7101 GILEAD RD

Re: 7111 Gilead Road
File: 3317B
Parcel: 009-032-17PO

At your request an inspection was made at the above referenced property to facilitate the issuance of an Operation Permit for the Sewage Treatment and Disposal system. During the inspection it was found that the following items did not meet the regulations set forth in the "Laws and Rules for Sewage Treatment and Disposal Systems, 15A NCAC 18A .1900;.1952 Septic Tank, Dosing, Dosing Tank and Lift Station Design." Our comments follow:

PROPOSED PLOT PLAN

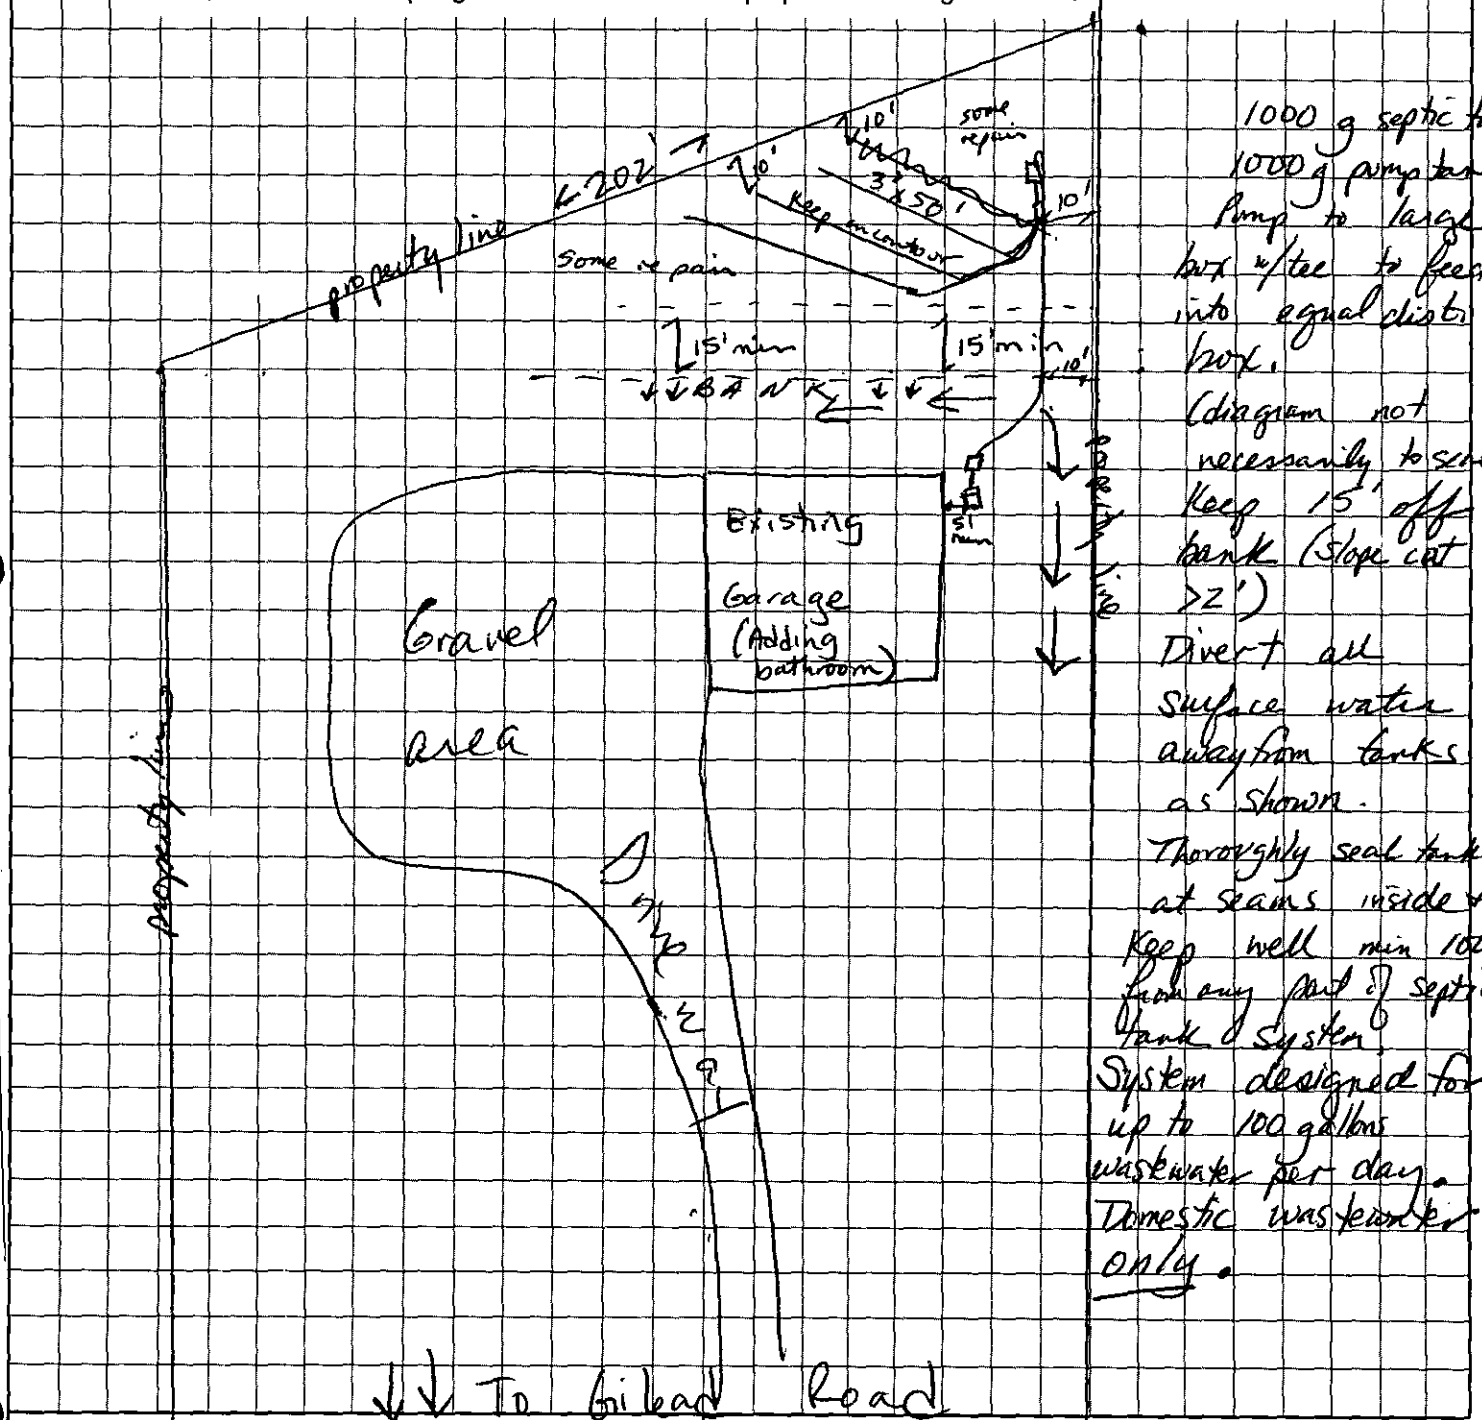
1000 g septic tank
1000 g pump tank
Pump to large bx w/tee to feed into equal dist bx.
(diagram not necessarily to scale)
Keep 15' off bank (Slope cat >2')
Divert all surface water away from tanks as shown.
Thoroughly seal tanks at seams inside tank.
Keep well min 100' from any part of septic tank & system.
System designed for up to 100 gallons wastewater per day.
Domestic wastewater only.

MECKLENBURG COUNTY HEALTH DEPARTMENT
SITE EVALUATION REPORT
SERIAL NUMBER 20500

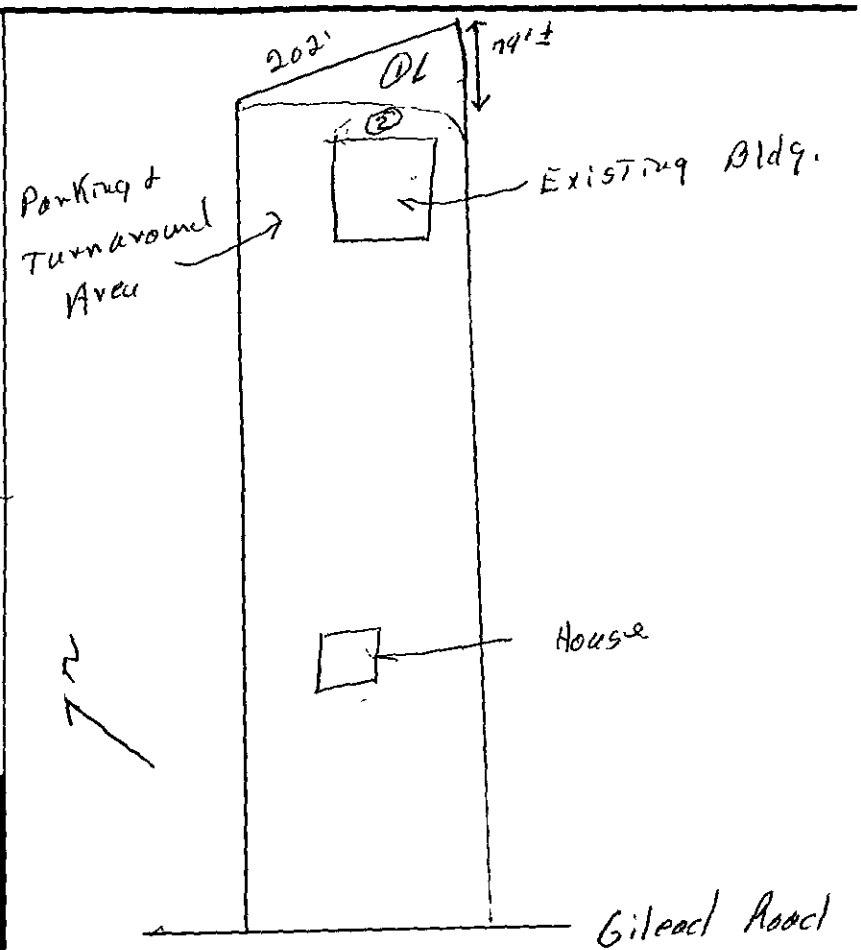
Comments: System would require pump, .3gal/ft²/day LTAR

FACTORS	AREA 1	AREA 2	AREA 3	AREA 4	AREA 5	AREA 6
Topography	(S) PS U 6-15%	S PS (U) unacceptable landscape position	S PS U	S PS U	S PS U	S PS U
Texture	S (PS) U Slight/M Expansive clay	S PS U	S PS U	S PS U	S PS U	S PS U
Structure	S (PS) U Sub A Blocky	S PS U	S PS U	S PS U	S PS U	S PS U
Drainage	(S) PS U 7+8" soil wetness	S PS U	S PS U	S PS U	S PS U	S PS U
Depth	S (PS) U 43"+	S PS U	S PS U	S PS U	S PS U	S PS U
Restrictive Horizons	S (PS) U 7+3"	S PS U	S PS U	S PS U	S PS U	S PS U
Available Space	S PS (U) Restricted Area	S PS U	S PS U	S PS U	S PS U	S PS U
Other (specify)	S PS U	S PS U	S PS U	S PS U	S PS U	S PS U
Soil Group/Series	IV Cecil-1.40	unacceptable Landscape Position				
Area Classification	S PS (U)	S PS (U)	S PS U	S PS U	S PS U	S PS U
